Report to the Future Melbourne (Planning) Committee

**Ministerial Referral: TPM-2014-43
57-63 Exhibition Street, Melbourne**

4 July 2017

**PLANNING REPORT
MINISTERIAL REFERRAL**

Figure 3: Excerpt from 'Shadow Study 22 June 11AM' prepared by Bates Smart

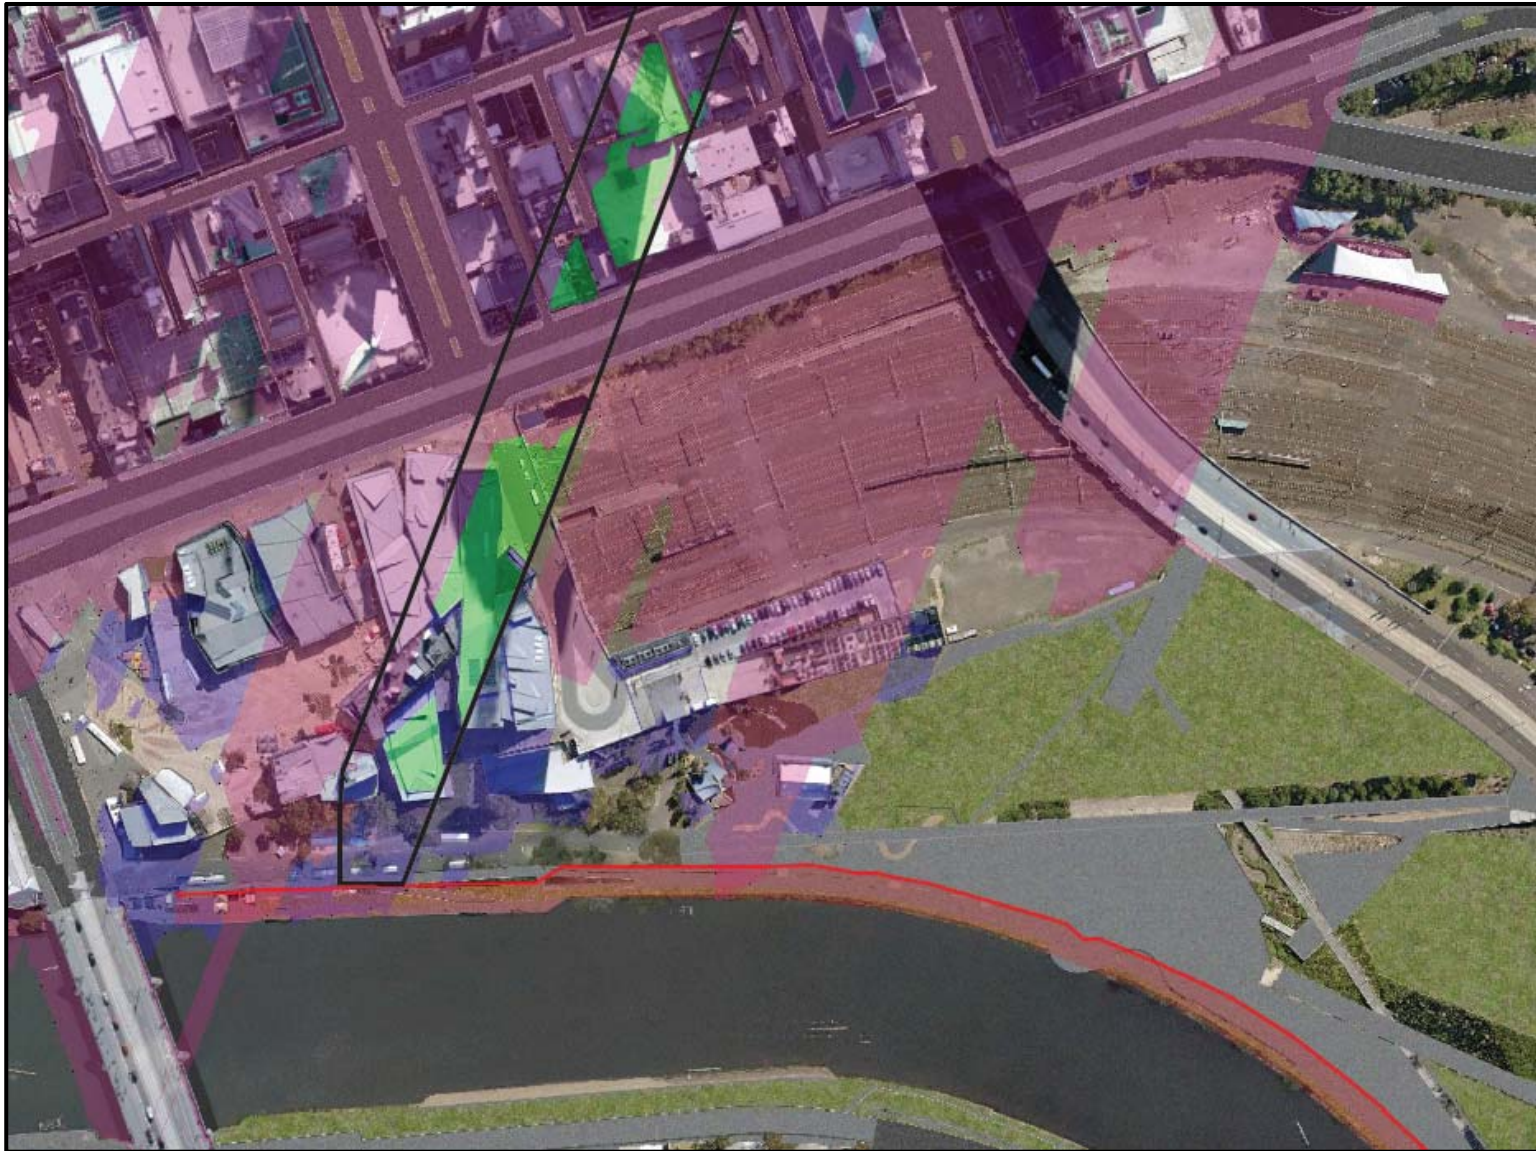
- The height of the proposed tower, RL 230.00 (corresponding to a height of 203.57 metres as measured from a spot level of RL 26.43 at the centre of the Exhibition Street frontage), appears to be a product of various local planning policy settings that have sought to limit the height of new development to prevent further shadowing of the north bank of the Yarra River (inclusive of a 15 metre wide strip of land extending north of the river edge) between 11.00am and 2.00pm on 22 June.

Figure 3 below includes an excerpt from shadow studies prepared by Bates Smart for 22 June at 11.00am, delineating the extent of the shadow cast by the tower (bold black line), in addition to the 'north bank' of the Yarra River (bold red line).

- The overshadowing associated with the proposed development will contribute to a significant loss of sunlight over Birrarung Marr, impacting on the Lower, Middle and Upper Terrace, as detailed in Figure # above.

6. To resolve the above issues, a number of conditions have been recommended for inclusion on any permit being granted, requiring; a reduction in the height of the tower to 183 metres to limit overshadowing impacts upon Birrarung Marr, fenestration to the southern boundary wall above a height of 80 metres, supporting material to demonstrate the feasibility of the angular glazed panel façade strategy, and a detailed plan of the ground floor plane responding to a number of specified criteria.

Figure 7: Excerpt from 'Immediate Context – Future Development' prepared by Bates Smart

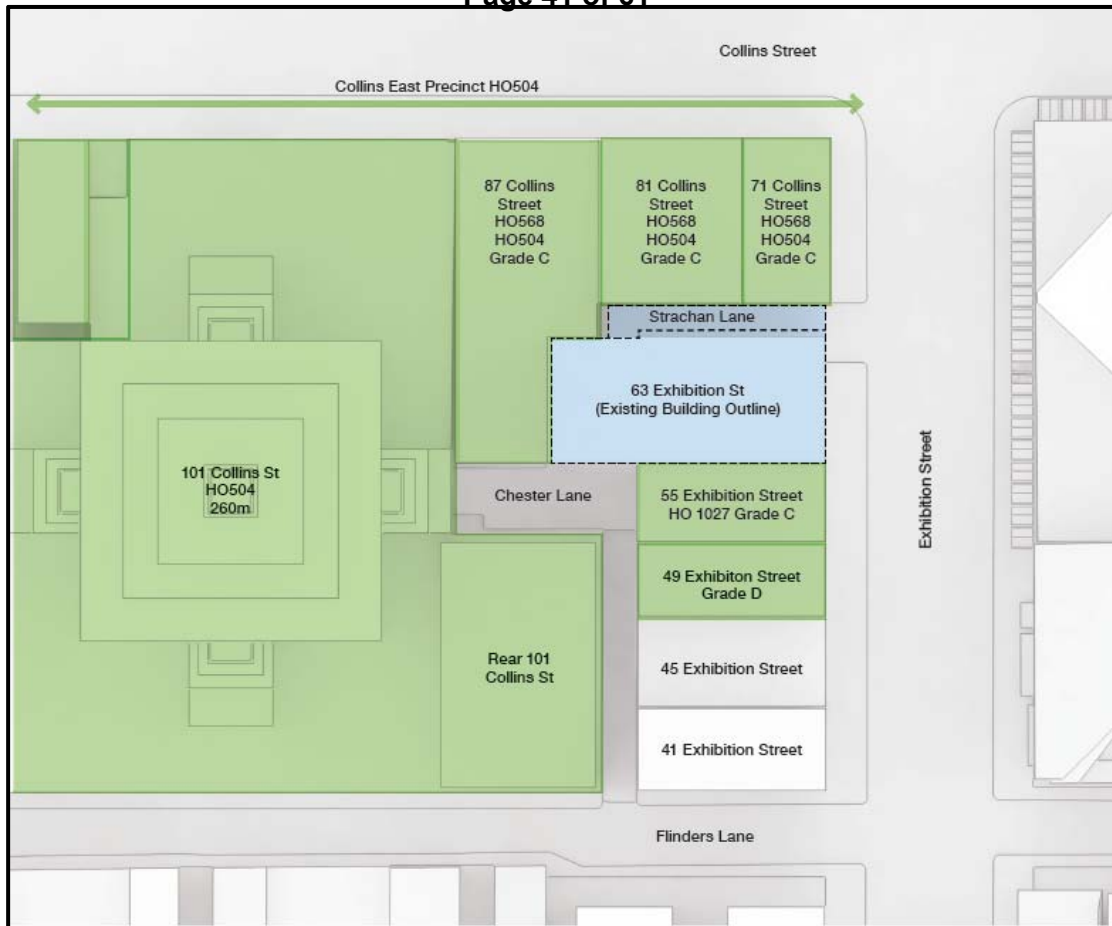
- 53-55 Exhibition Street is occupied by a graded historic building protected under a site specific Heritage Overlays, limiting the scale of potential future development (see Figure 7 overleaf for a map showing heritage protected properties surrounding the subject property).

Figure 8: Excerpt from 'Immediate Context – Future Development' prepared by Bates Smart

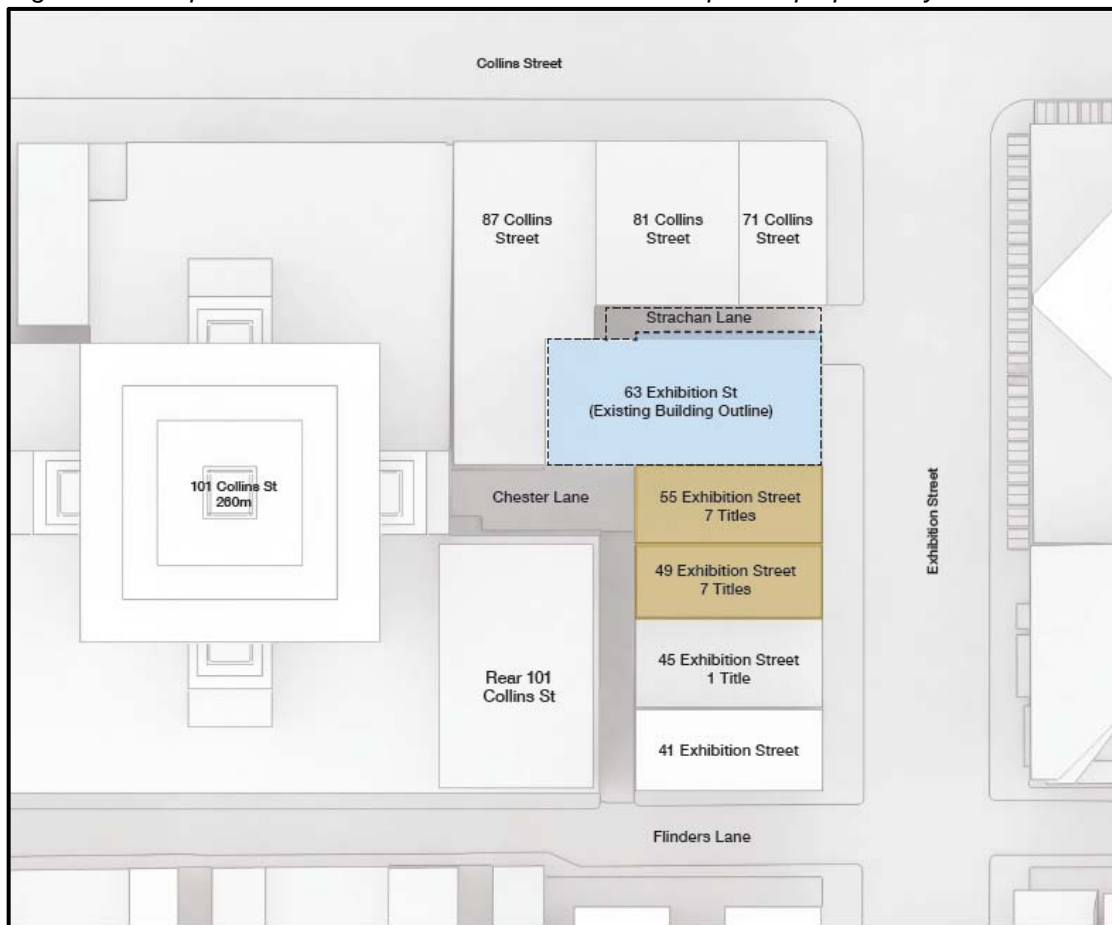
- The title to 53-55 Exhibition Street and its neighbouring property to the south, 49 Exhibition Street, have been strata-subdivided and are subsequently in fragmented ownership (currently in use for dwellings) limiting the likelihood of these lots being consolidated to enable development (see Figure 8 on page 23 above for a map showing fragmented titles surrounding the subject property).
- Per analysis by Bates Smart, in the unlikely event that the adjoining property to the south at 53-55 Exhibition Street and its neighbour at 49 Exhibition Street were consolidated, Schedule 10 to the Design and Development Overlay would render development of a tower form with a height greater than 80 metres on the consolidated property unviable.

A reasonable requirement, having regard to the likely development envelope for the adjoining property at 53-55 Exhibition Street, and the need to provide a degree of activation to the southerly façade of the proposed development, would therefore be to condition the provision of windows to bathrooms on floors above RL 107.00, to the south façade abutting the shared property boundary with 53-55 Exhibition Street, Melbourne.

Figure 9: excerpt from plan titled '1.4 Strachan Lane Podium Projection, prepared by Bates Smart

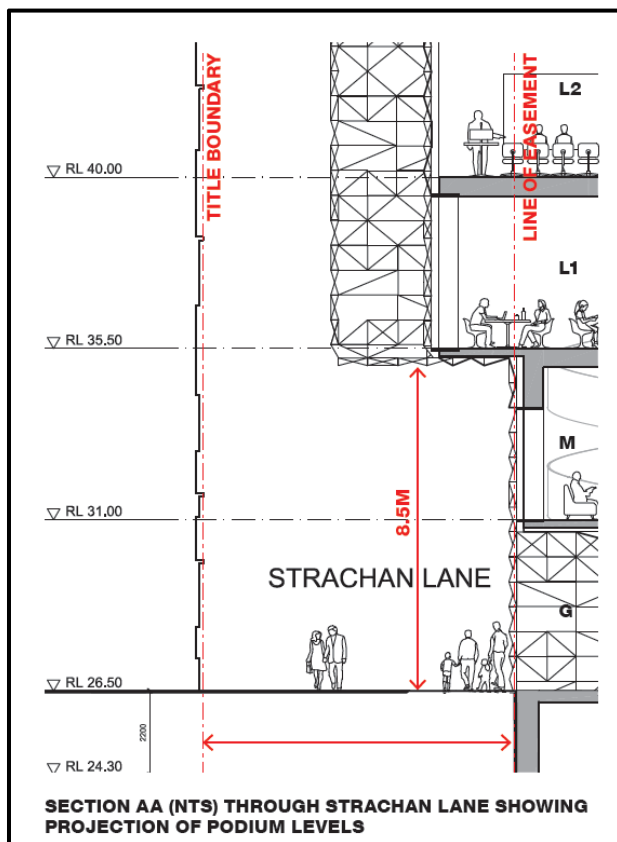
- The north-west corner of the podium (measuring 2.334m x 7.189m) and tower (measuring 1.034m x 7.189m) will project over easement 'E-1' on Title Plan 819012Q, representing the current Strachan Lane alignment.
- Detailed plans provided by the applicant showing the extent of this encroachment over Strachan Lane identify that the minimum clearance from the laneway surface to the underside of the cantilevered podium is 8.5 metres (see Figure 9 below).

It is noted that the encroachment of the podium over Strachan Lane (easement E-1 on Title Plan 819012Q) has previously been considered by Council's Engineering Services Branch at a meeting held on 24 March 2016, where no concerns were identified subject to adequate clearance being provided above the laneway surface in accordance with Council's Road Encroachment Operational Guidelines.

- Subject to conditions recommended by Council's Land Survey team being included on any permit being granted, prompting the permit holder to obtain approval to build over easement E-1 on Title Plan 819012Q from Melbourne City Council it is considered the development will achieve compliance with Clause 22.01-6.

Figure 10: Excerpt from 'Accessibility Marked Plan' (Ground Floor) dated 17 May 2016 prepared by Du Chateau Chun Pty. Ltd.

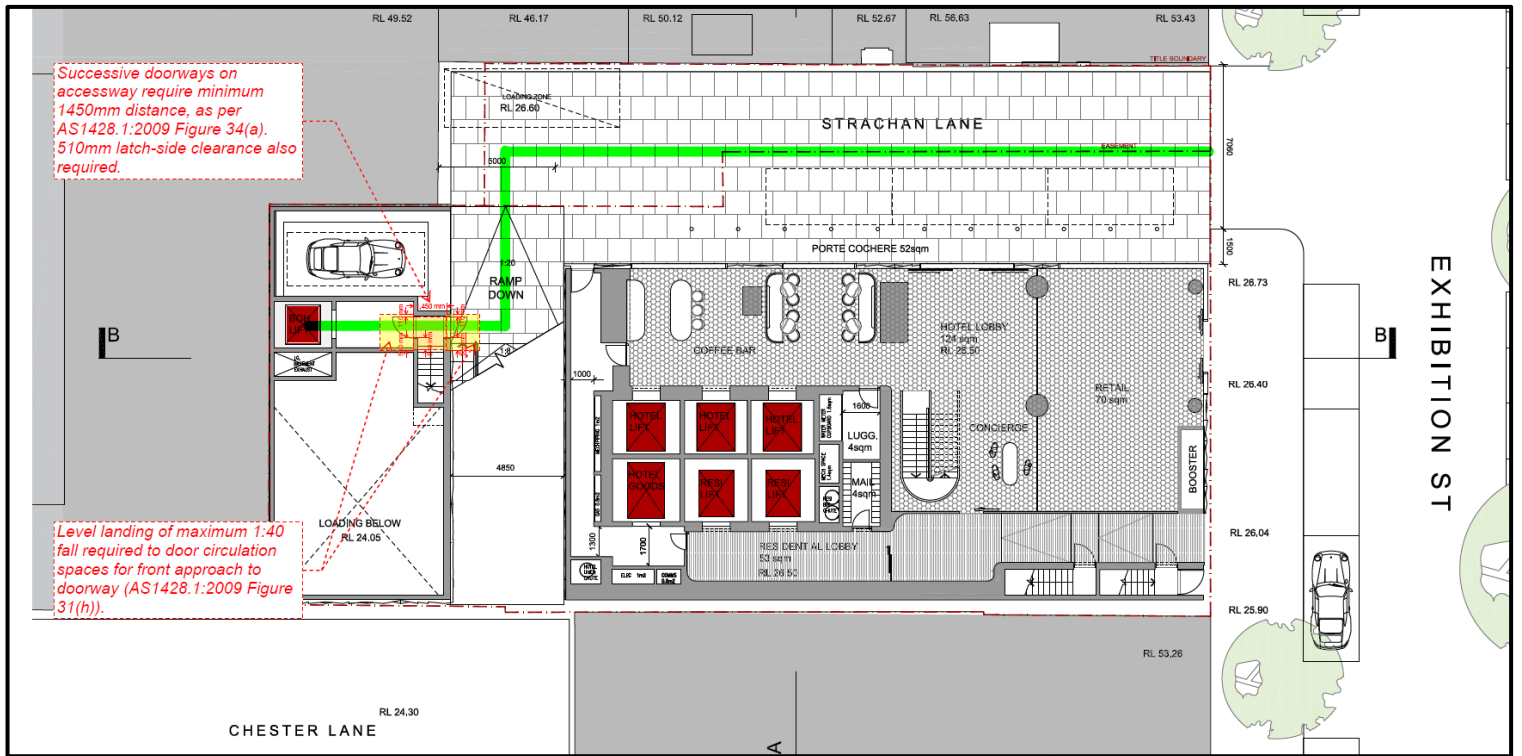
The advice and solution offered by Du Chateau Chun Pty Ltd will result in a highly segregated and unequal outcome for persons with disabilities, and is not considered to represent an appropriate outcome for a public thoroughfare (see Figure 10 and Figure 11 overleaf for excerpts from the wayfinding plan prepared by Du Chateau Chun Pty Ltd.).

- v. Employ an alternative response to provide DDA compliant access via the through-block link that does not rely on a concierge operated lift with egress through a loading bay.

Figure 12: Excerpt from report prepared by MEL Consultants Pty. Ltd. dated June 2016 detailing wind conditions at ground level for proposed development.

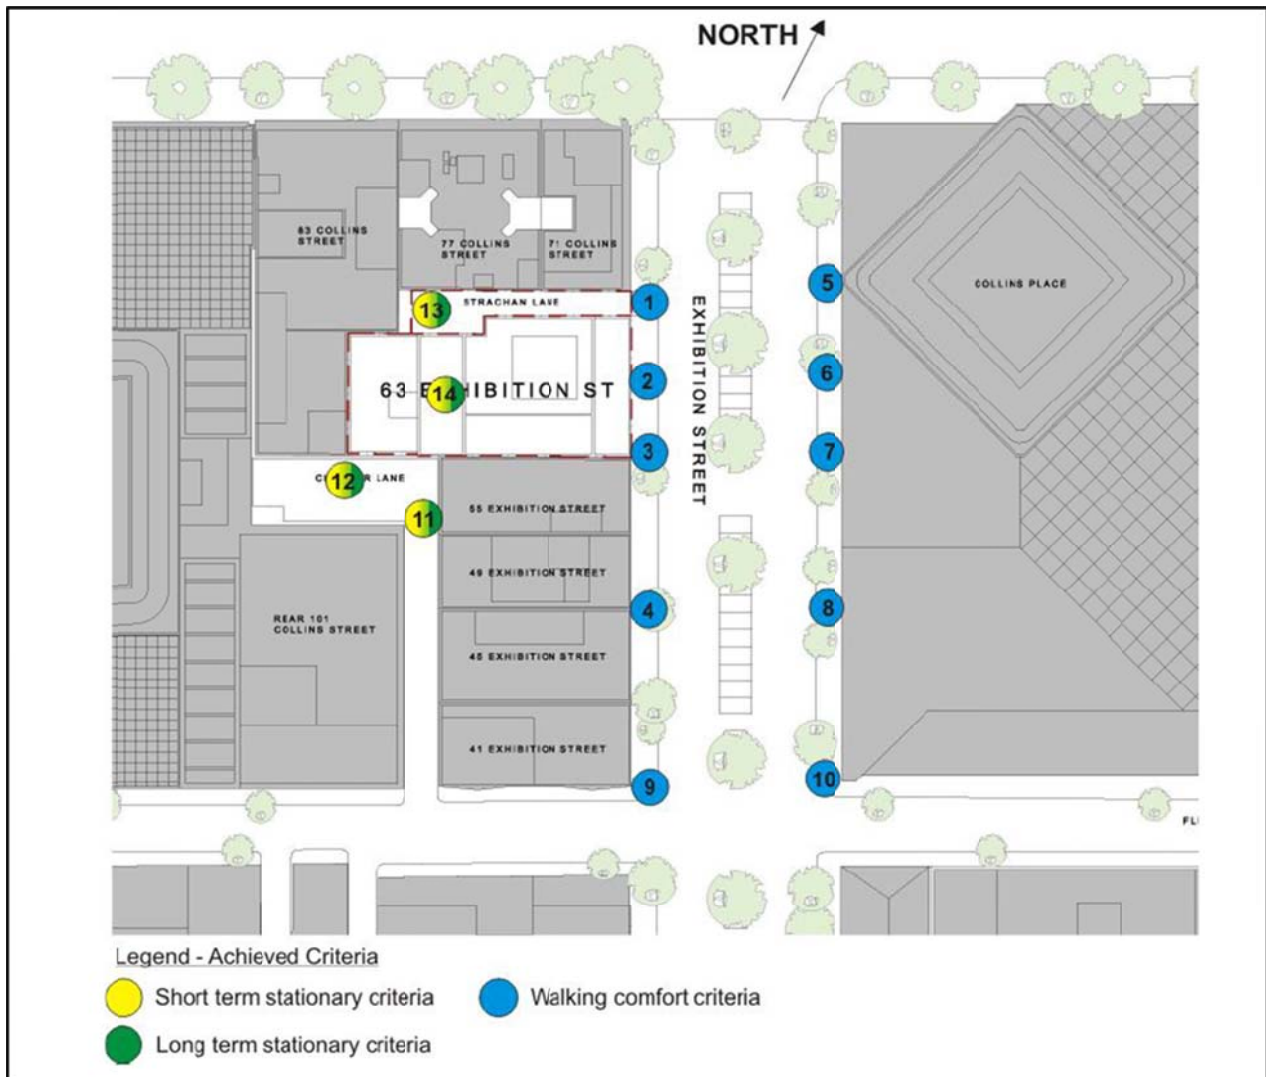
The report prepared by MEL Consultants Pty. Ltd. dated June 2016, which documents findings from a wind tunnel model of the proposed development, identifies that the proposed development will meet specified short and long term stationary comfort criteria, and walking comfort criteria in accordance with the excerpt from this report provided below in Figure 12.

As detailed in section 8.6.1 of this report above, subject to a condition being included on any permit being granted requiring provision of a canopy over the residential apartment entry to provide protection for residents of the building, the development will not contribute detrimentally to wind speeds at ground level, or compromise pedestrian comfort and amenity.
